# **CAP Meeting Agenda**

DEVELOPMENT NO.:	23022401
APPLICANT:	Alison Lowrie
ADDRESS:	64 ESSEX ST S GOODWOOD SA 5034
NATURE OF DEVELOPMENT:	Demolition of existing dwelling and construction of a two storey detached dwelling and fencing
ZONING INFORMATION:	<ul> <li>Zones:</li> <li>Established Neighbourhood</li> <li>Overlays:</li> <li>Airport Building Heights (Regulated)</li> <li>Affordable Housing</li> <li>Building Near Airfields</li> <li>Historic Area</li> <li>Prescribed Wells Area</li> <li>Regulated and Significant Tree</li> <li>Stormwater Management</li> <li>Traffic Generating Development</li> <li>Urban Tree Canopy</li> <li>Technical Numeric Variations (TNVs):</li> <li>Maximum Building Height (Metres) (Maximum building height is 6m)</li> <li>Minimum Frontage (Minimum frontage for a detached dwelling is 10m)</li> <li>Minimum Site Area (Minimum site area for a detached dwelling is 300 sqm)</li> <li>Maximum Building Height (Levels) (Maximum building height is 1 level)</li> <li>Minimum Side Boundary Setback (Minimum side boundary setback is 1m for the first building level; 3m for any second building level or higher)</li> <li>Site Coverage (Maximum site coverage is 50 per cent)</li> </

Figure 3 – 15m 45 degree overlooking diagram

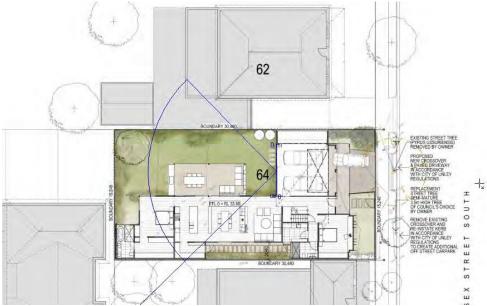
The proposal demonstrates the upper-level side and rear windows have sill heights a minimum of 1.6m above the upper-level finished floor level bar the upper-level bedroom. Based on the above diagrams the outlook from this window will not directly overlook any adjoining private open space or habitable window and does not require screening. Figure 3 demonstrates this below:

Given the above, this design satisfies **PO 10.1** and overlooking has been adequately mitigated.

SUN STUDY JUNE 21st 9AM

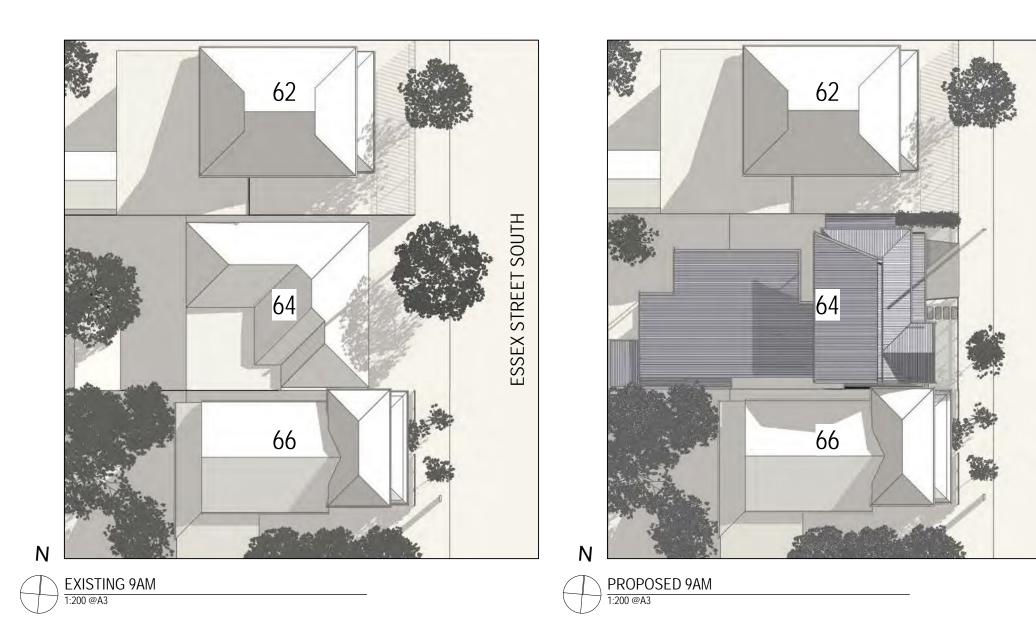
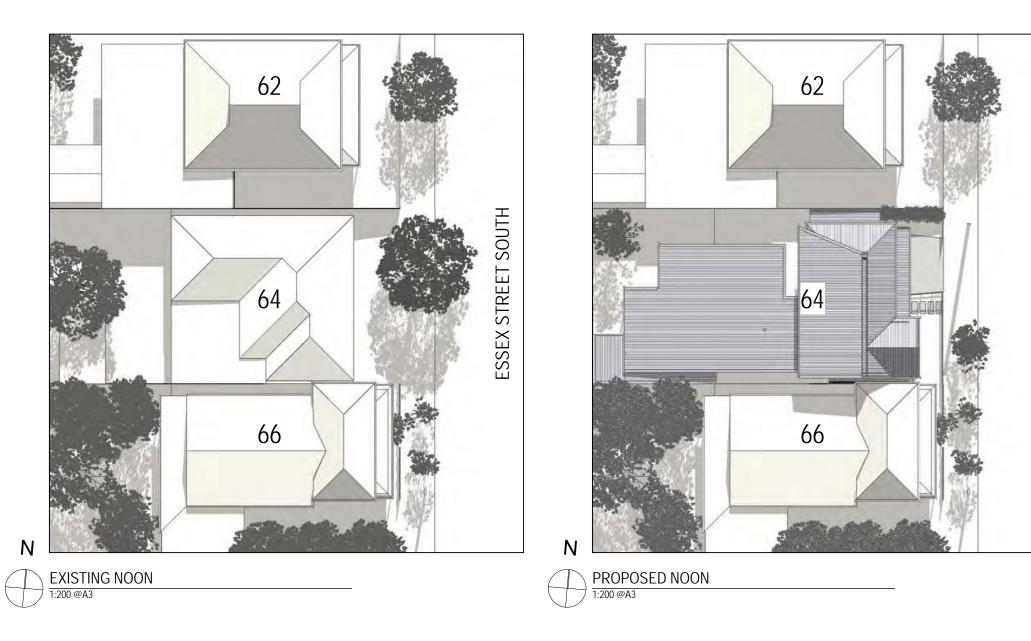
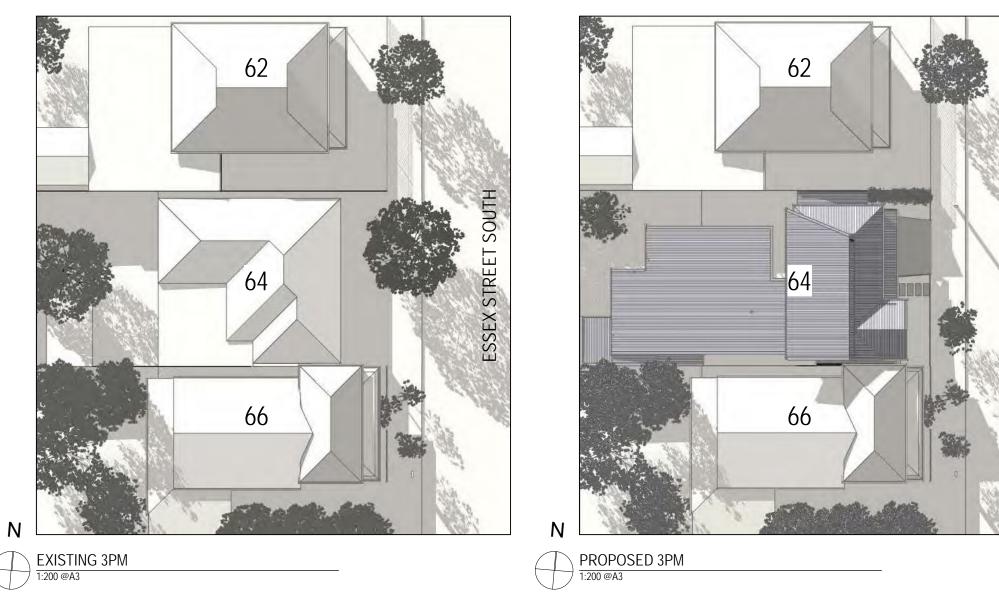
One representor raised concerns regarding overshadowing to their property located to the south of the subject site at 66 Essex Street South. The applicant provided a series of shadow diagrams demonstrating the extent of overshadowing by the upper level in response to these concerns, **Attachment 3** and **5**. These shadow diagrams show the upper level of the dwelling will cast a shadow to the south over the adjacent dwelling from early morning to early afternoon with limited shadowing to the private open space.

### 2. Shadowing

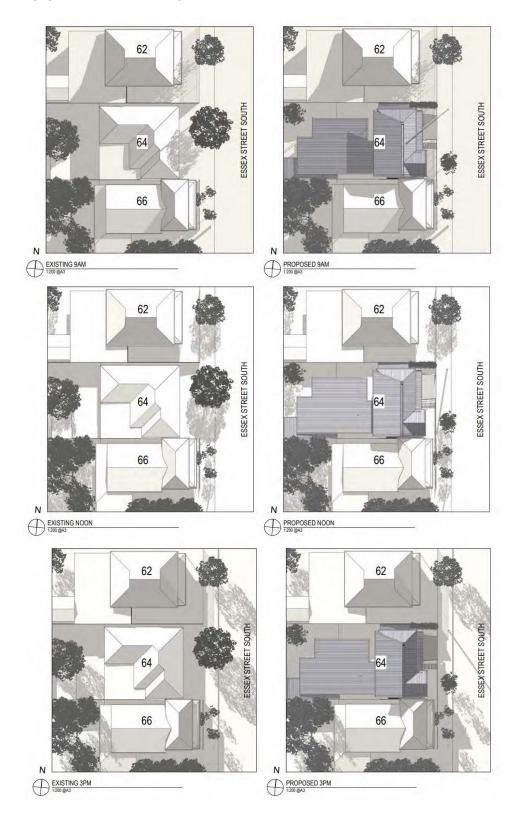
The following shadow diagrams demonstrate that the adjoining dwelling to the south will continue to enjoy suitable sunlight to private open space, noting that the current arrangement of buildings and fencing on the shared boundary already cast shadow, with negligible increase arising.

16A backyard view

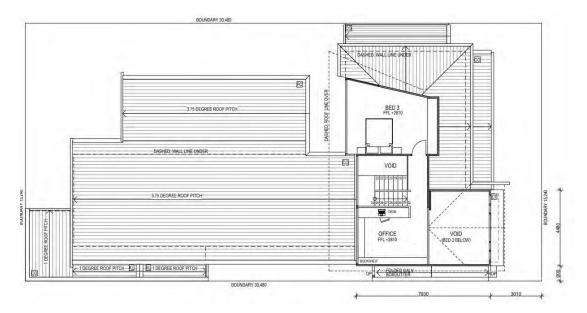
In response to the concerns expressed by two of the representors in relation to the potential for overlooking from the east facing upper level home office towards, the Architect has prepared a very useful analysis for your consideration, presented in both 3D and plan view.

In so far as line of sight may be possible from this upper level room, it is not to an extent that would seriously compromise the privacy that may continue to be enjoyed on these residential properties opposite on the other side of Essex Street, noting that with respect to #53 the limited view is into the front yard area.

It is not thought necessary to introduce additional screening to this window given the horizontal distance between the viewpoint and the areas in question, noting that there is to be a void to the bedroom below on the ground floor of some 4 metres together with a solid balustrade.

Proposed new street tree planting to the front of the property will also filter views.
